SERVICE LETTER

65-23

SUBJECT: FUEL SYSTEM MODIFICATION

MODELS AFFECTED: 182 and Skylane

Figure 1. Fuel Lines Installation

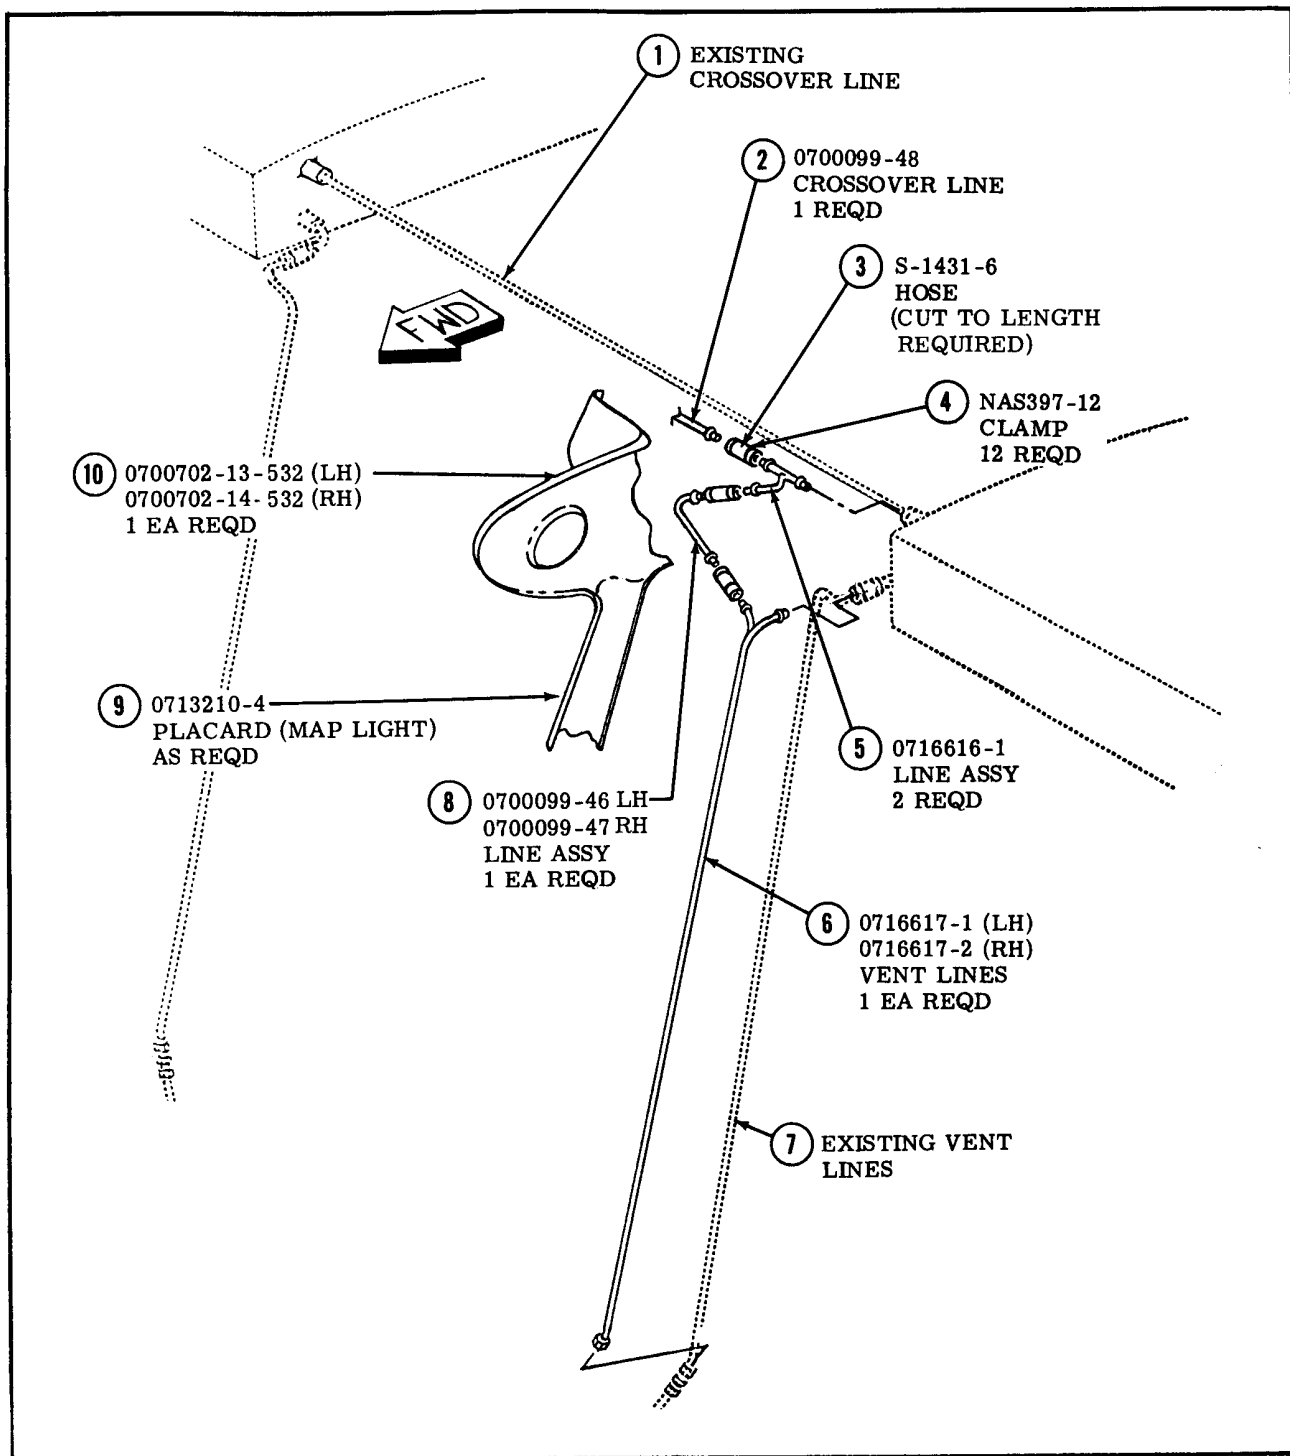
- (1) Replacing the existing "cross over" and forward doorpost fuel vent lines with new lines.
- (2) Replacing the upper doorpost upholstery shields with new shields which are formed to accommodate the shape of the new fuel vent lines.

b. (Refer to figure 1.) Fuel Lines Installation.

- (1) Loosen hose clamps and remove existing "cross over" fuel line (1).
- (2) Loosen hose clamps and remove existing right and left hand front doorpost fuel vent lines (7).
- (3) Install new lines, clamps and hose as shown.

- (4) Install new doorpost shields (10). Transfer map light to new LH shield if existing in aircraft. Apply decal furnished in kit to shield for map light identification.
- (5) Refuel aircraft and check for leaks.
- (6) Reinstall all previously removed items of equipment.

Figure 1. Fuel Lines Installation

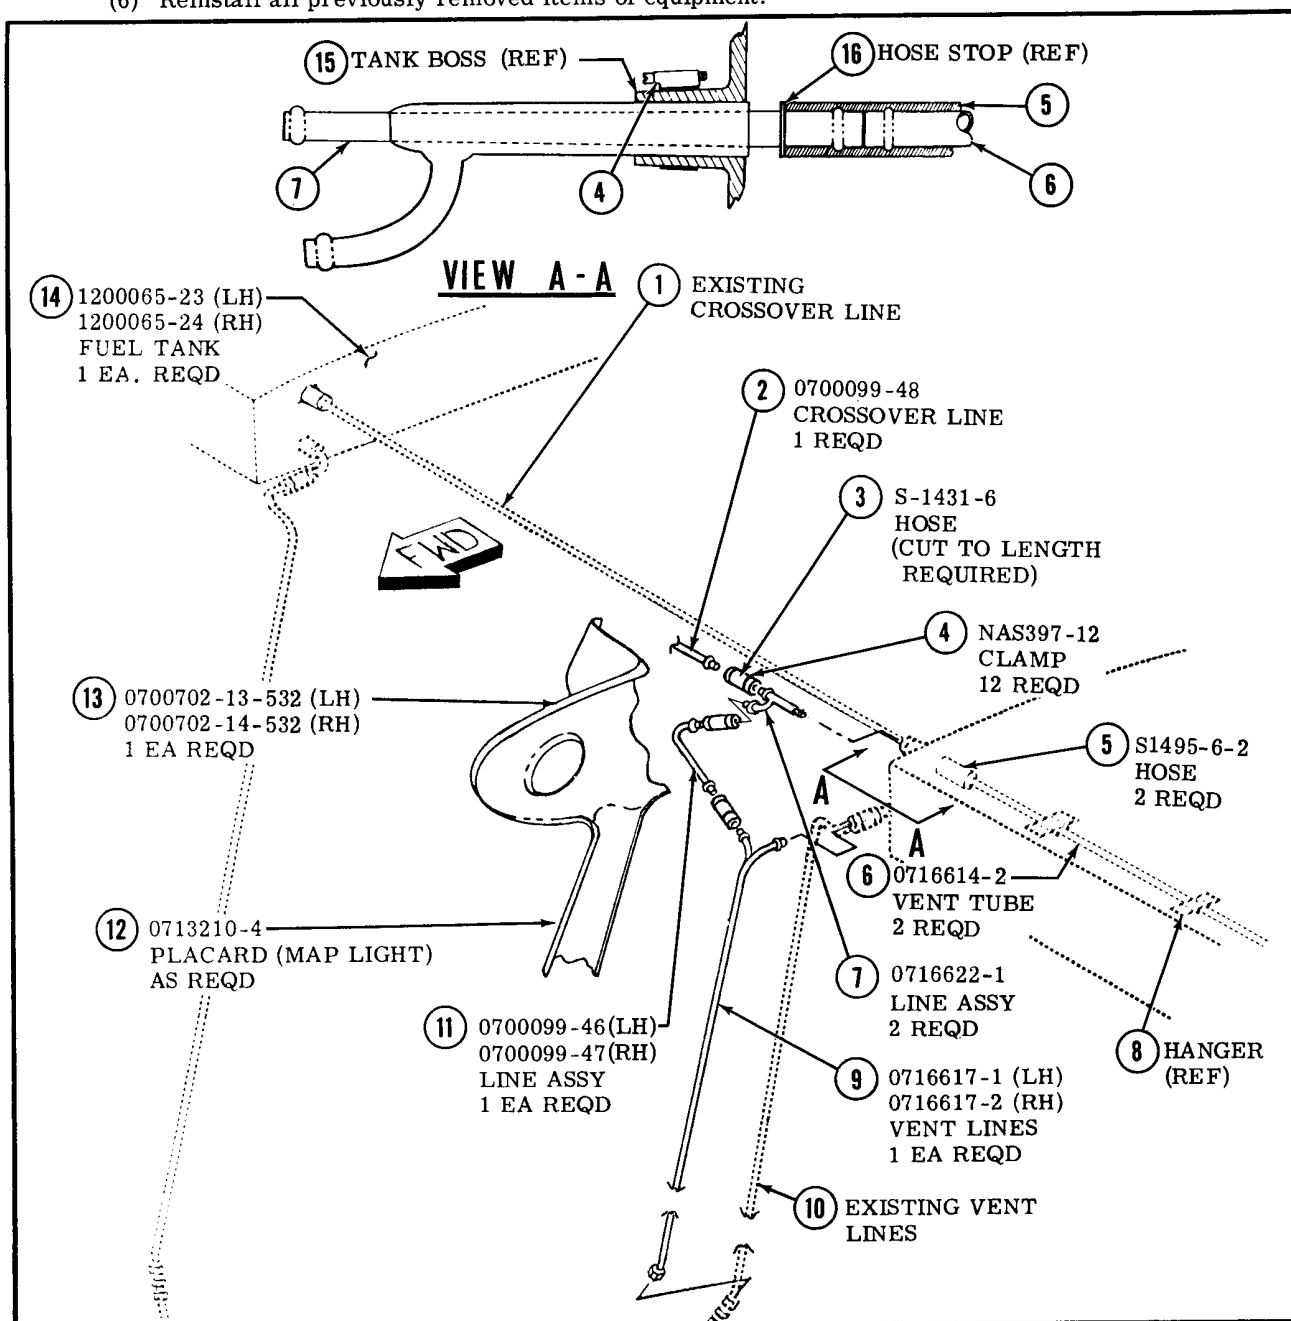
- (1) Replacing the existing 3/8" boss fuel tanks with new 5/8" boss fuel tanks.
- (2) Replacing the existing "crossover" and forward doorpost fuel vent lines with new lines.
- (3) Replacing the upper doorpost upholstery shields with new shields which are formed to accommodate the shape of the new fuel vent lines.

b. (Refer to figure 1.) Fuel tank and lines installation.

- (1) Install new fuel tanks using new fuel transmitter gaskets and reconnect overboard vent line.
- (2) Install all new lines as shown.
- (3) Install hose (5) over end of line (7) inside tank and insert beaded end of vent (6) thru rings in hangers (8) and into open end of hose (5). No clamping is required.
- (4) Install new doorpost shields (10). Transfer map light to new LH shield if existing in aircraft.
- (5) Refuel aircraft and check for leaks.
- (6) Reinstall all previously removed items of equipment.
